**2020 CMOM Package 3 (Applewhite)  
Solicitation Number: CO-00548  
Job No.: 20-4519**

**ADDENDUM 1  
August 12, 2022**

**OVERALL QUANTITY SHEET**

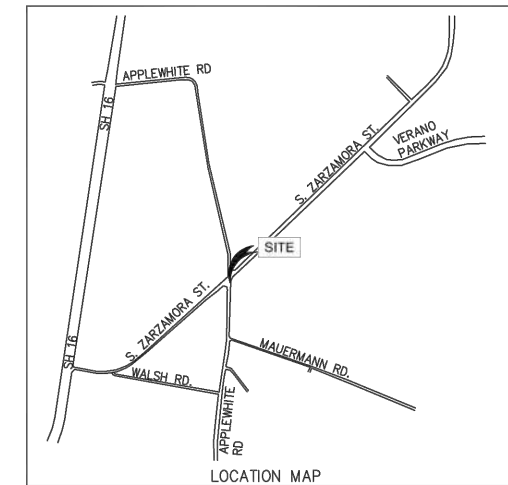
1. Sheet C1.02: Overall Quantity Sheet – Remove in its entirety and replace with the attached document.
  - Added Flowable Fill, Sanitary Sewer Lateral, Two-way Sanitary Sewer Cleanout and Bypass Pumping (Small Diameter Sanitary Sewer Mains) quantities, revised Hot Mix Asphaltic Pavement, Tack Coat, Salvaging, Hauling and Stockpiling Reclaimable Asphaltic Pavement, and Open Cut Lateral Reconnection quantities

**SURVEY CONTROL SHEET  
S ZARZAMORA ST & APPLEWHITE RD**

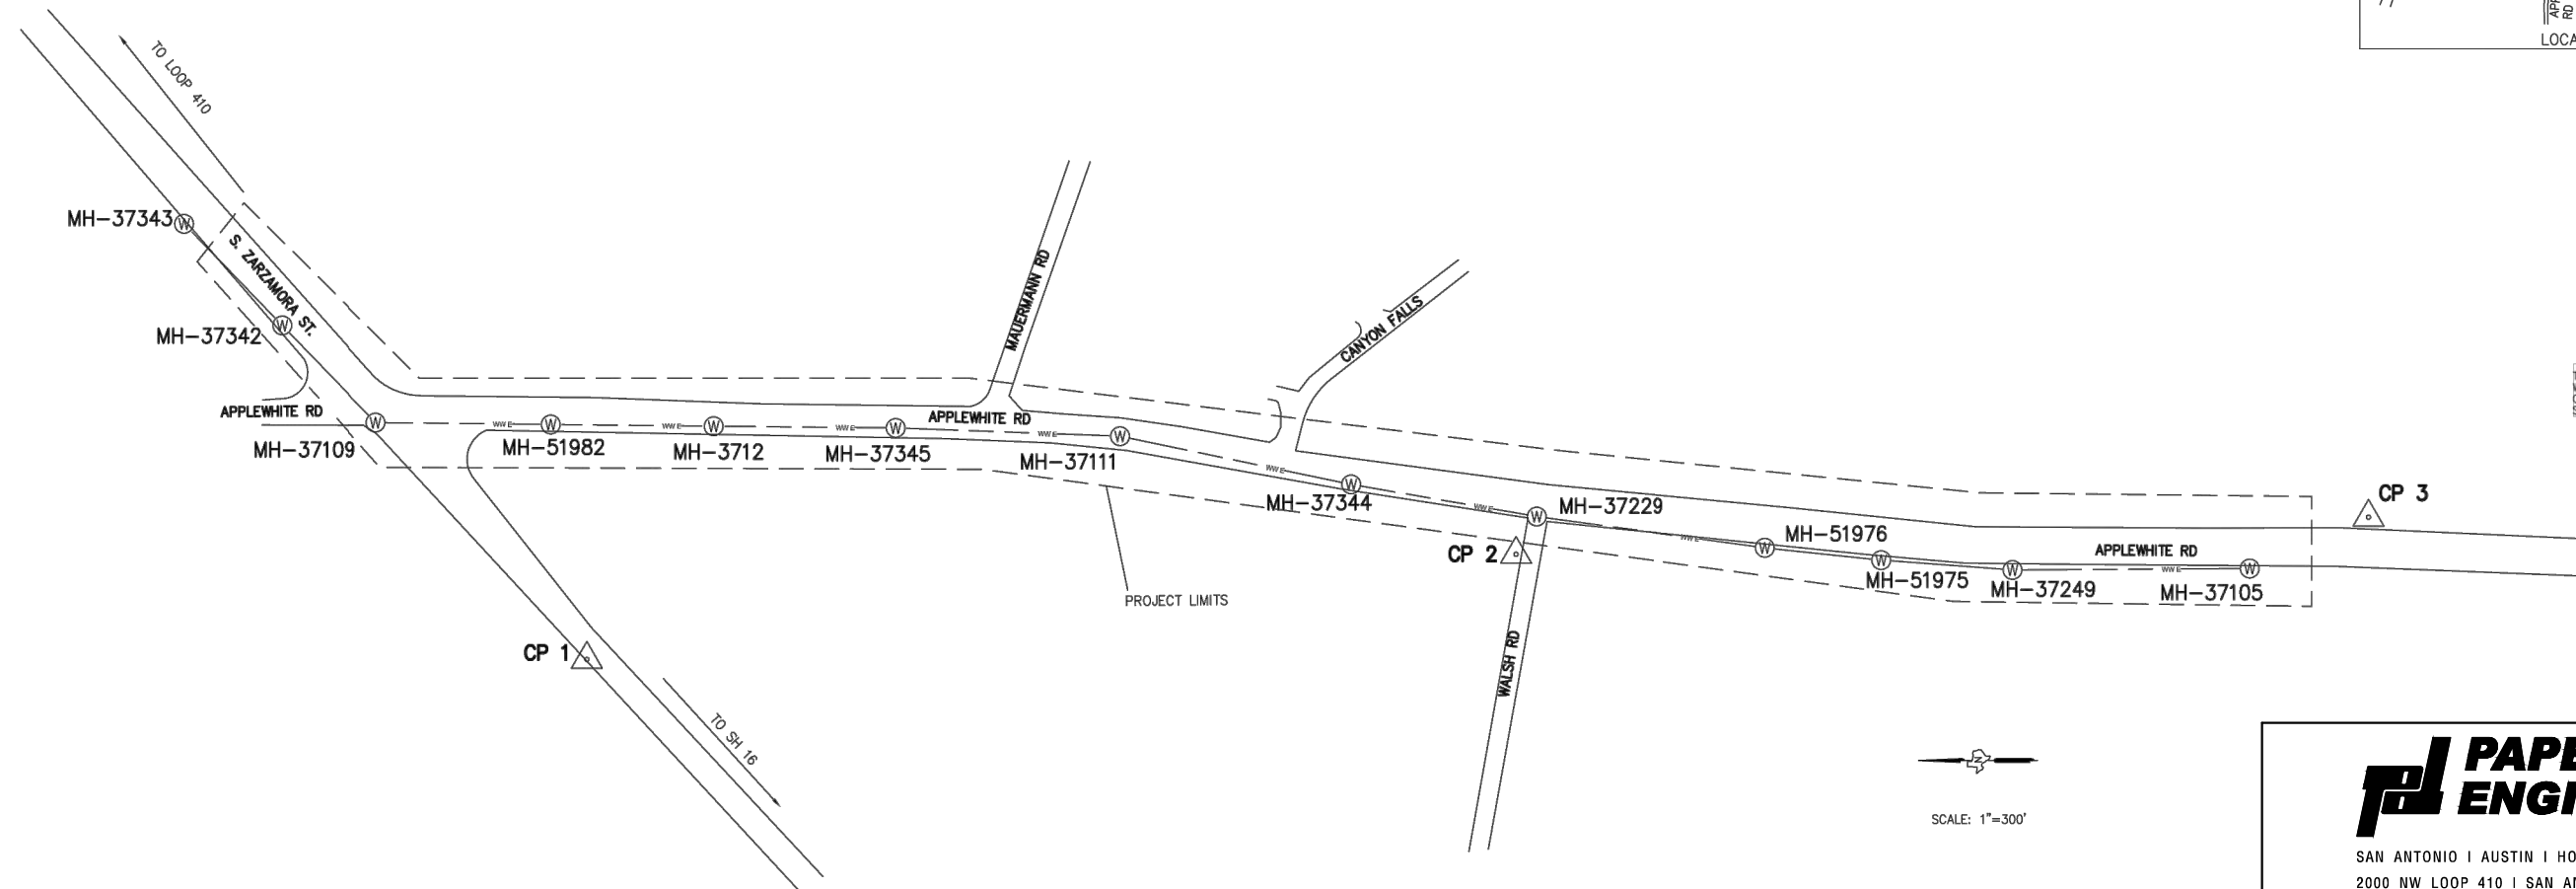
2. Sheet C2.10 — Survey Control Sheet – Remove in its entirety and replace with the attached document.
  - Replaced with signed and sealed survey control sheet from Vickrey & Associates

**SUGGESTED BYPASS LAYOUT - PHASE 1**

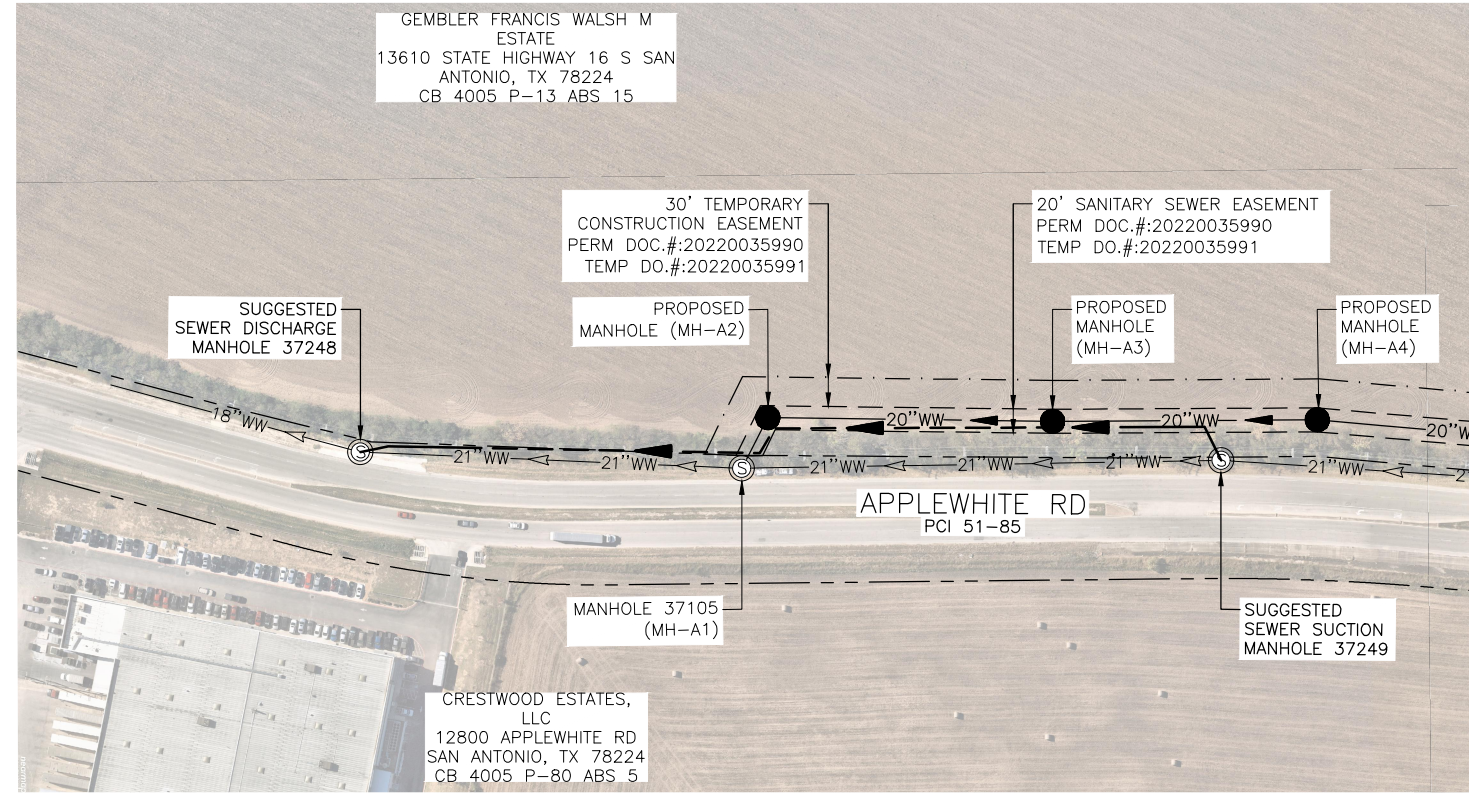
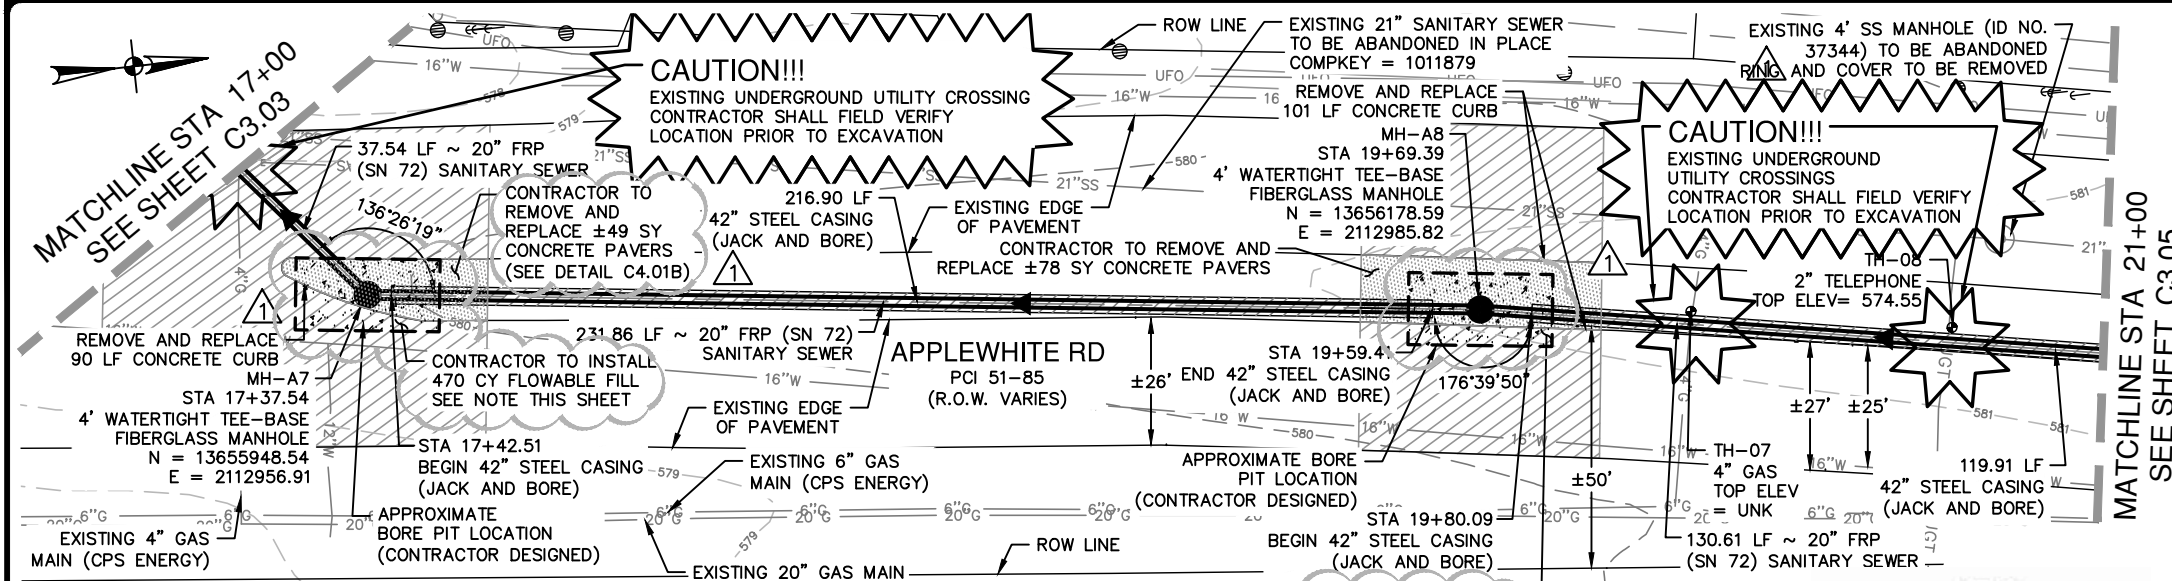
- 1. Please provide existing flows for the bypass.**  
*Please refer to "Flow Data" note on plan sheets C2.41, C2.42, and C2.43 for existing flows for the bypass.*

3. Sheet C2.41 –Suggested Bypass Layout – Phase I – Remove in its entirety and replace with the attached document.
  - Added Bypass Pumping (Small Diameter Sanitary Sewers) quantity

**LINE A - PLAN AND PROFILE SHEET STA 17+00 TO STA 21+00**

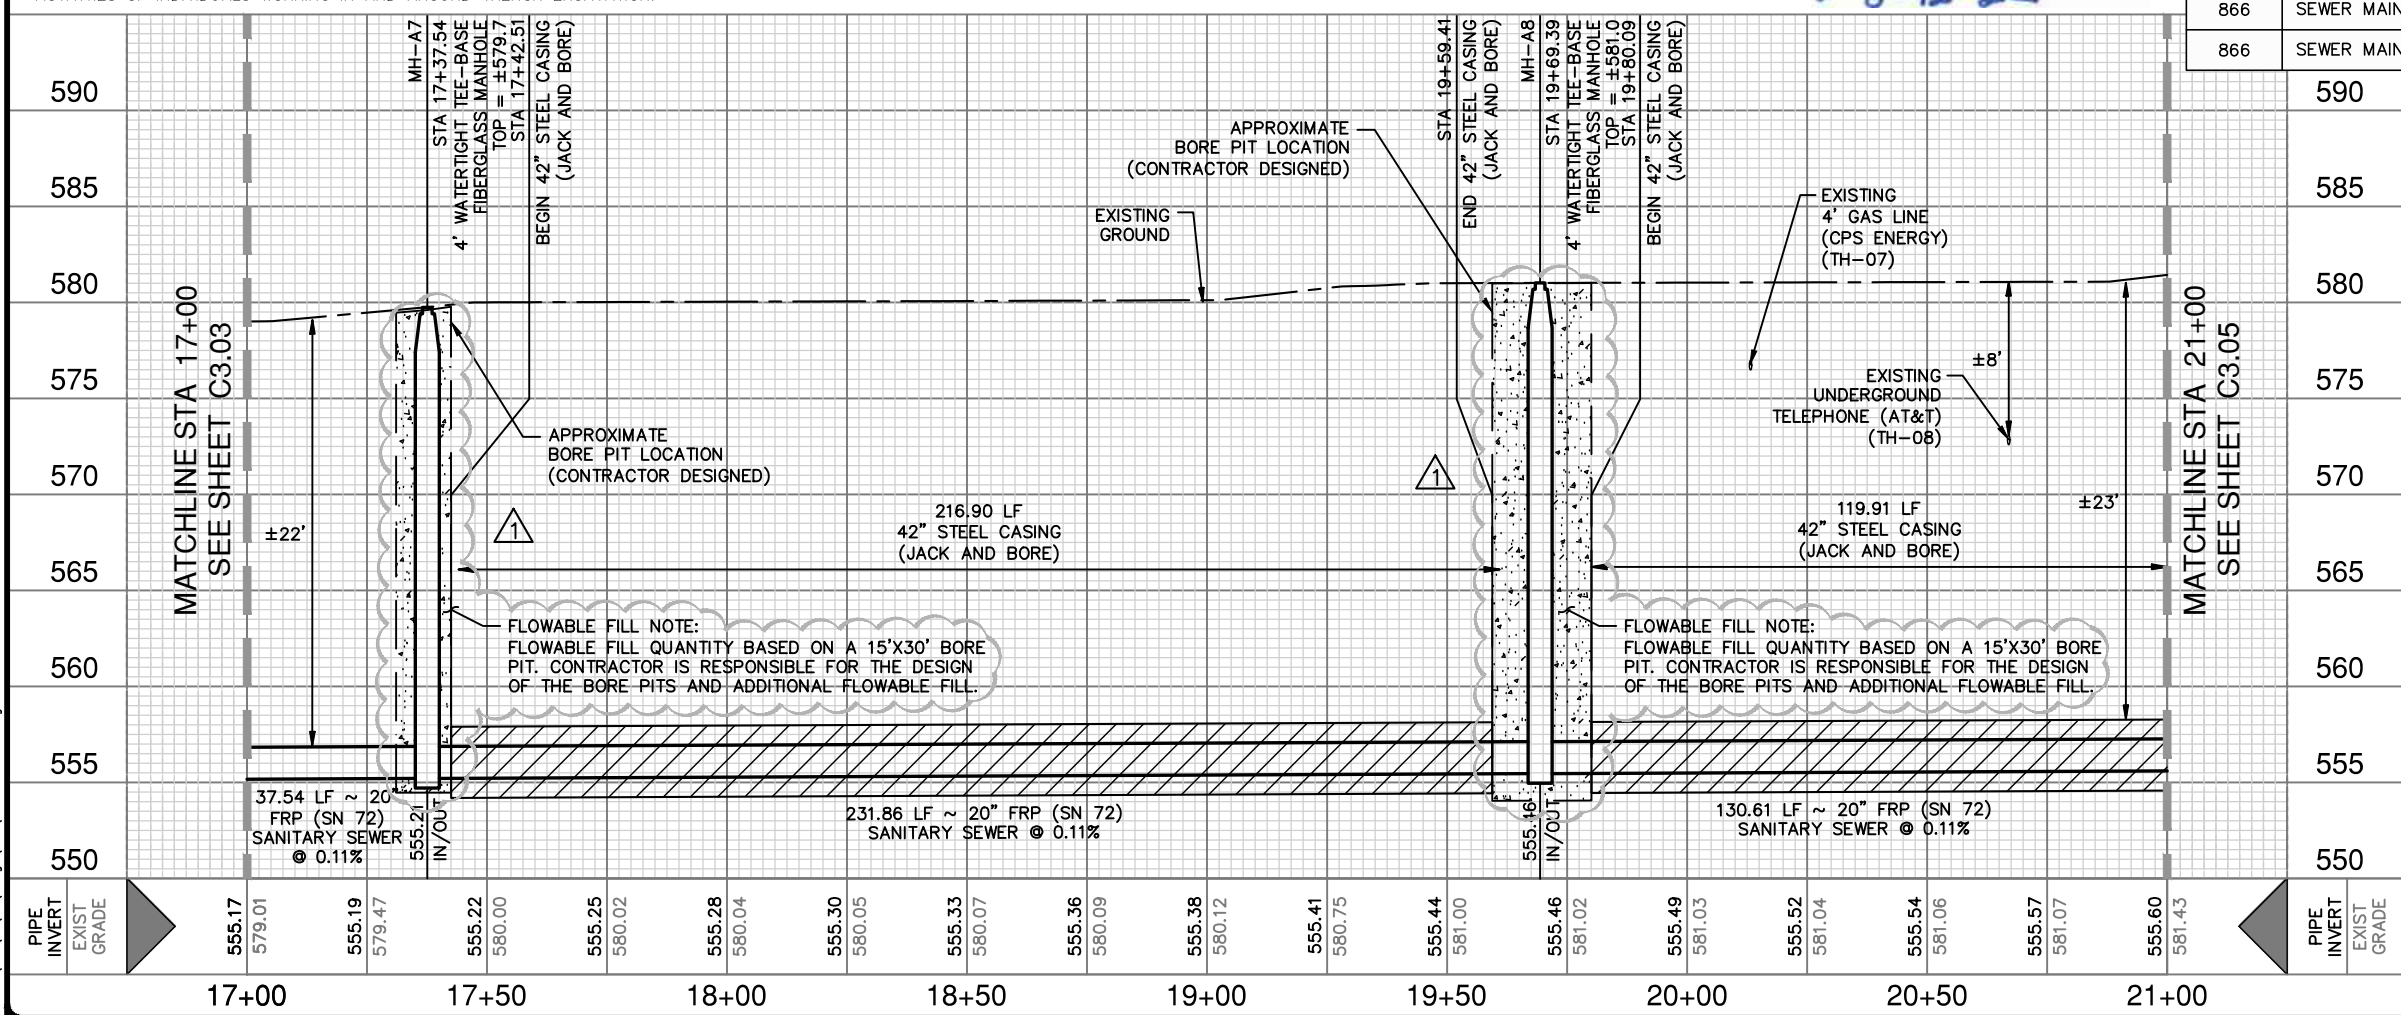
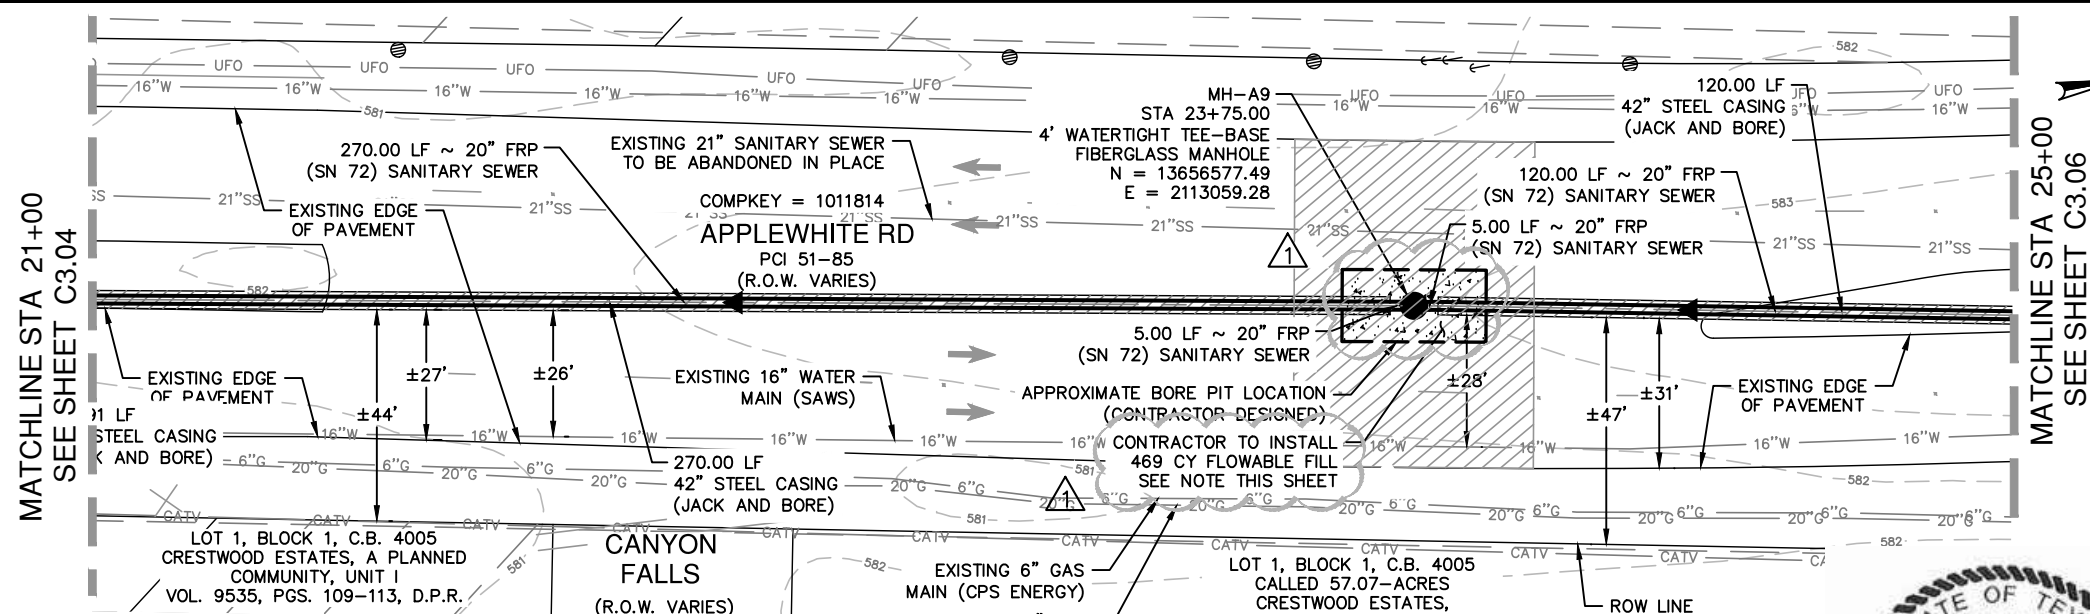
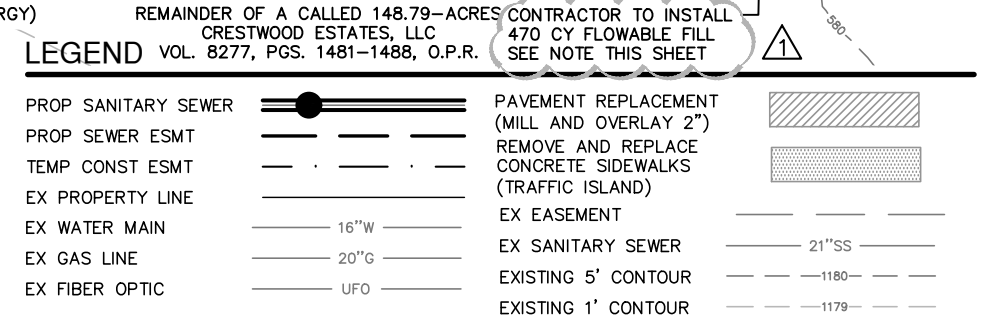
- 3. For the bore pits being on the road and so close to the existing sewer line, can you provide flowable fill backfill bid item. It will be difficult to compact after installation of manhole and with those depths the existing pavement will cave in if you try to compact the bore pits.**  
*Additional flowable fill has been added to the plans and quantities to account for backfilling of the proposed bore pits on sheet C3.04, C3.05, C3.06, C3.07, and C3.08.*

- 5. Is there any additional information on the concrete pavers? The CoSA spec referenced is for concrete sidewalks and it doesn't talk about concrete pavers and there isn't anything in the plans that shows a detail for the pavers.**  
*Concrete pavers to match existing pattern and color as shown in detail C4.01B.*

4. Sheet C3.04: Line A – Plan and Profile Sheet Sta 14+00 to Sta 21+00 – Remove in its entirety and replace with the attached document.
  - Added Flowable Fill quantity and note, revised concrete paver callout
